Subject: Recall No. 99V-132

Subject: Recall Campaign for 1999 GSX-R750 and GSX-R600 Motorcycles - Cam Chain Tension Adjuster

4-STROKE BULLETIN NO. GS/GSX/GSX-R-107

## SAFETY RECALL CAMPAIGN GSX-R600X & GSX-R750X **CAM CHAIN TENSION ADJUSTER**

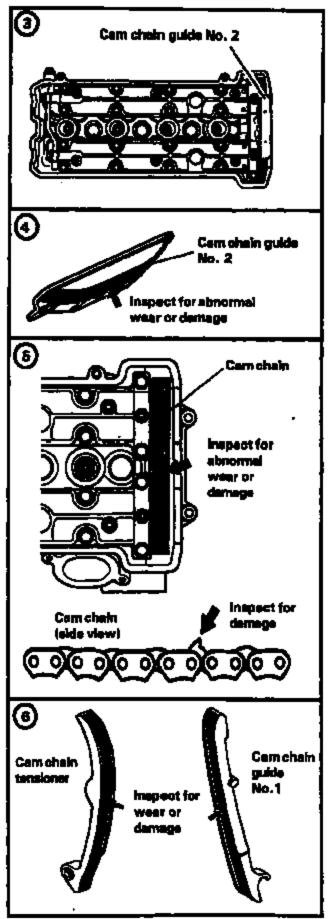
(Fig.4) inspect the chain contact surface of the removed cam chain guide No.2 for any abnormal wear or damage.

If the chain contact surface of the cam chain guide No.2 is abnormally worn or damaged, the engine will require disassembly to clean oil passageways of debris and to inspect other engine components for damage.

(Fig. 5) Inspect the carn chain for damage. You can slowly rotate the crankshaft manually to inspect the carn chain. Look at the chain plates from above and from the side for evidence of damage. Demaged chains must be replaced and the engine disassembled, inspected and cleaned of debris.

(Fig. 7) If the inspection indicates the original carn chain guide and carn chain are in good condition, instell the new carn chain guide No. 2.

The new cam chain guide No.2 can be identified by the profile of the rubber portion of the guide.

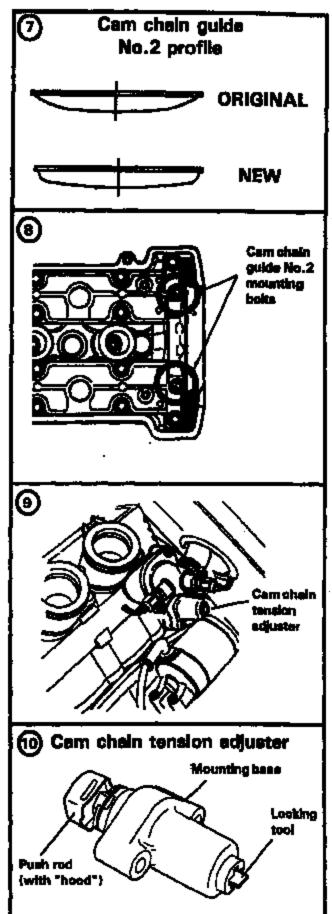
(Fig. 10) The new style tension adjuster can be identified by the hood-like cover over the push rod and by the thicker mounting base, which requires the longer mounting bolts included in the recall parts kit.

(Fig. 11) inspect the tension adjuster to ensure it is the correct one for the motorcycle you are servicing. The tension adjuster can be identified by the thickness of the mounting base portion of the adjuster.

GSX-R600X ORIGINAL A 12.0 mm
GSX-R600X NEW STYLE B 19.5 mm
GSX-R750X ORIGINAL A 12.0 mm
GSX-R750X NEW STYLE B 16.5 mm

Make sure you install the correct tension adjuster on the motorcycle. The tension adjuster for the GSX-R500 and the GSX-R750 appear similar, but there are differences in construction and push rod spring rate. Engine damage can occur if the wrong tension adjuster is installed.

(Fig. 12 & 13) Install the new gasket and the new style cam chain tension adjuster. Use the new mounting bolts supplied with the recall service parts kit.
